This document summarized point-to-point responses to the comments from two anonymous referees, and a list of main changes in the manuscript.

## Comments and responses to referee#1

Figure: 4km-grid simulation domain over Yangtze River Delta (YRD).

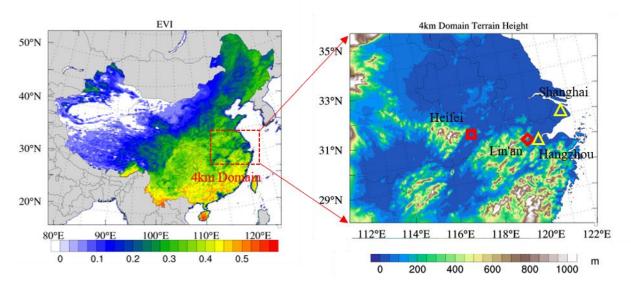
**Comment#3:** The fine resolution (20-km) is too coarse to capture Lin'an's footprint area, which would be roughly < 4 km at the height level under stable conditions. Therefore, it is hard and a bit unreasonable to directly compare with local-scale measured fluxes.

We conduct a new set of simulation with 4km grid resolution with exactly the same configuration over a smaller domain, as shown in the following figure (Figure 1(b) and (d) in revised manuscript). The new 4km-grid simulation has a domain size as 215 (south-north)  $\times$  280 (west-east) grid points over a significantly smaller domain than the 20km-grid simulation domain. The 4km-grid simulation showed very similar result to the 20km-grid simulation. Thus the 20km-grid simulation was used to characterize the spatiotemporal distributions of CO<sub>2</sub> over China, and the 4km-grid simulation was only used to compare with tower data collected at Lin'an tower. Detailed comparison will be shown in the response for comment#3. Our major conclusion was not changed, thus we do not attempt to rerun the whole China domain simulation with 4km grid resolution due to limited computational resource.

**Figure**: Locations where footprint reaches peak value (left); Locations where the fetch-to-height ratio equals 90%. Both units are meters.

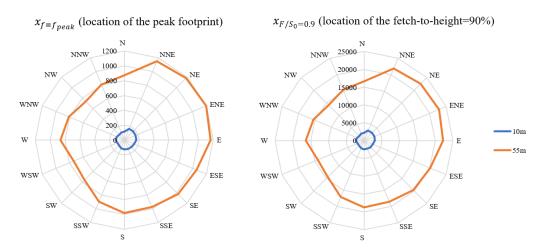
**Comment#10:** Line 300: Footprints at each level of the flux site should be quantified **Response**: We agree with the referee that showing the footprints would be a straightforward demonstration to support the discussion regarding transport impact, but unfortunately there was no wind speed and wind direction measurement at 21m of the Lin'an tower. We only have wind observations at 10m and 55m. We apply the method proposed by Hsieh et al. (2000) to calculate footprints at these two levels. The scalar flux (F) and the footprint (f) are related by (equation 1 in Hsieh et al. (2000)):

The above figure demonstrates that upper air (55m) received influences from prominently longer distances than lower air (10m). Considering the dominant upwind directions are northwest at Lin'an tower (figure in response to comment#4), it's likely that 55m at Lin'an had larger footprints than 21m from Hangzhou. Footprint was mentioned at line#296 and line#300 in the original manuscript. In that paragraph, we attempted to demonstrate that the boundary layer stability was closely correlated with the CO<sub>2</sub> concentration gradient. Footprint was mentioned to further the discussion by demonstrating that 55m received more influence from Hangzhou than 21m. We assumed that upper air usually has larger footprint than lower air. However, this comment reminds us that we are not able to solidly demonstrate it because no wind speed and wind direction measurement was available at 21m. Thus we decide to remove the discussion regarding footprint (line#295-302 in original manuscript) in this revision, and our main conclusion in this paragraph remains unchanged.

**Figure** 7: Seasonal mean diurnal variations of observed  $CO_2$  at (a) 21m and (b) 55m; WRF-VPRM simulation biases of  $CO_2$  at (c) 21m and (d) 55m; CT2019 simulated biases at (e) 21m and (f) 55m; Simulated NEE from (g) WRF-VPRM and (h) CT2019.

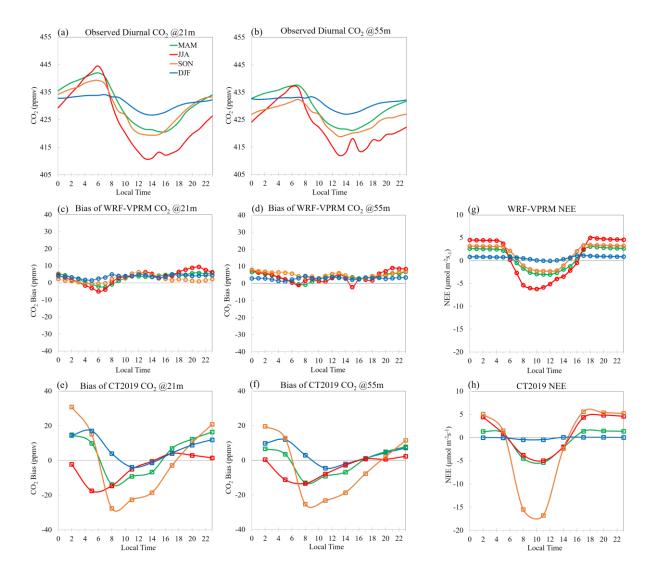
**Comment#13** Figure 6. The scale of the y-axis must be matched for a clear comparison. **Response**: The y-axis in Figure 6 has been adjusted accordingly as shown in the following figure (Figure 7 in revised manuscript). As recommended in comment#7, we reorganize the figure by removing the wind speed figure (c) as shown below. We also use wider distance between the CO<sub>2</sub> concentration figures (a-f) and NEE figures (g and h).

**Figure**: Photos of the (a) Lin'an regional atmospheric background station and (b) the data analysis lab; and wind rose map at Lin'an derived from wind speed and wind direction observations for 2016-2018 at (c) 10m and (d) 50m.

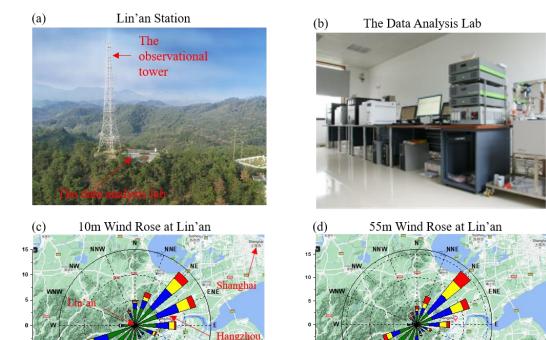
**General Comment#3**: I fully agree with Reviewer #1 in that more details are needed with respect to the description of the model setup, but also the observation sites. For example, only at the end of the discussion it is mentioned that the city of Hangzhou is located 60 km away from the Lin'an tower. This clearly belongs to the description of the data used, ideally in a specific section within the methods section, entitled for example "atmospheric observations".

**Response**: We agree with the two referees that more details are necessary to provide a clear description of the observational sites and modeling method. Regarding the details of Lin'an site, the following figure had been added to show the locations of Lin'an tower, downtown Hangzhou, and Shanghai, along with wind rose figures to demonstrate the prevailing winds at 10m and 55m at Lin'an tower. We have also added a few more sentences in the revised manuscript (line#131-137) describing the location and prevailing winds at Lin'an tower.

**Figure**: Locations where footprint reaches peak value (left); Locations where the fetch-to-height ratio equals 90%. Both units are meters.

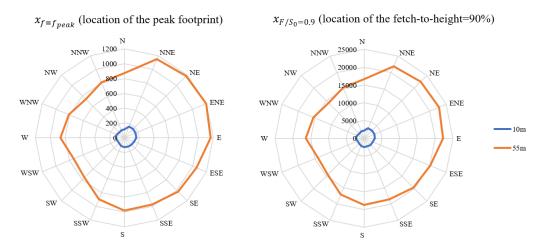
**Comment#13:** Line 187: The attribution of model-observation discrepancy to the vertical allocation of emissions is not plausible. It would be required to at least state the distance of upstream (strong) emission sources that could have an impact on the CO2 profile over the site.

The above figure shows the peak locations (left) of footprint and the location where the fetch-to-height ratio equals 90% (right) at 10m (blue lines) and 55m (orange lines) of Lin'an tower respectively. At 55m height, the peak location of footprints were about 1.2km from NNE, NE, ENE, and E directions. The location of fetch-to-height ratio equals to 90%

were about 22km, suggesting that the upwind areas within this distance contribute 90% to the 55m height at Lin'an tower. This footprint can serve as one example to indicate the distance that upwind sources may affect the CO2 profile. More details of the footprint calculation and discussion were presented in the response for comment#10 for the other referee (<a href="https://editor.copernicus.org/index.php/acp-2020-1128-AC1.pdf?\_mdl=msover\_md&\_jrl=10&\_lcm=oc108lcm109w&\_acm=get\_comm\_file&\_ms=90658&c=196331&salt=840354016545253938">https://editor.copernicus.org/index.php/acp-2020-1128-AC1.pdf?\_mdl=msover\_md&\_jrl=10&\_lcm=oc108lcm109w&\_acm=get\_comm\_file&\_ms=90658&c=196331&salt=840354016545253938</a>). As we were comparing CO2 at 21m and 55m but there was no wind data at 21m, we decided not to include the discussion of footprint in the manuscript but only provide it here.

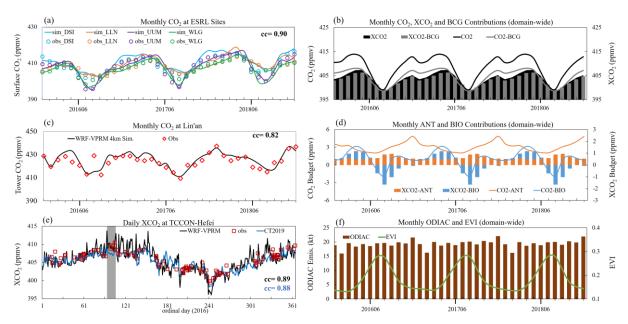
**Comment#17:** Line 209, Fig 4c: I suggest using daytime values at the Lin'an tower. Note that the air samples at the NOAA stations are also taken during daytime, usually in a well-mixed boundary layer. Otherwise nocturnal peaks in (modeled or observed) CO2 will simply dominate.

**Response**: We greatly appreciate the referee for this helpful comment. We have updated the figure and related discussion with daytime data from observation and model. The correlation was increased from 0.77 to 0.82. Fig 4c in the original manuscript was Fig.5(c) in the revised manuscript, as shown below.

**Figure**: Comparison of WRF-VPRM simulated daily variations of biospheric fluxes (left column) and meteorology (right column) between Wuying (top row) and Lin'an (bottom row).

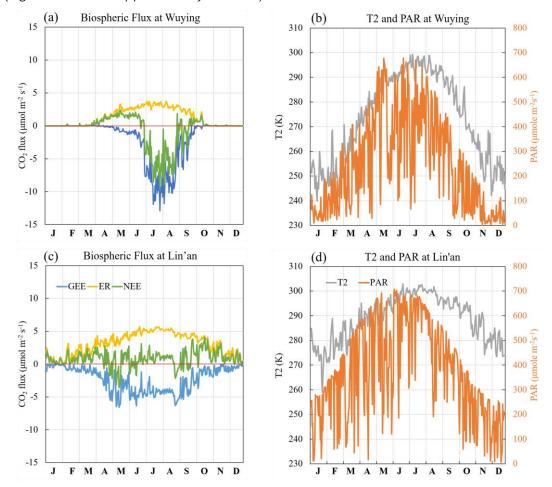
**Comment#21:** Line 265: "may have also estimated" I assume that there is corresponding output from WRF-VPRM with hourly biosphere fluxes from respiration and photosynthesis, such that it can be confirmed that WRF-VPRM simulates non-zero respiration during nongrowing season.

**Response**: Yes, WRF-VPRM did provide hourly outputs of respiration and photosynthesis uptake. In this sentence (line#265) we intended to say "may overestimate the nighttime respiration". We apologize for the typo induced misunderstanding. We had no flux measurements at Lin'an thus unfortunately we cannot evaluate if the nighttime respiration was overestimated. Li et al. (2020) validated the hourly respiration with eddy covariance data at a mixed forest site Wuying (47.15°N, 131.94°E), so we compared the simulated respiration and photosynthesis uptake between Wuying and Lin'an to indicate that the model may overestimate respiration in warmer areas where VPRM did calculate respiration as non-zero during nongrowing season, as shown in the following figure (Figure S5 in the supplementary material).
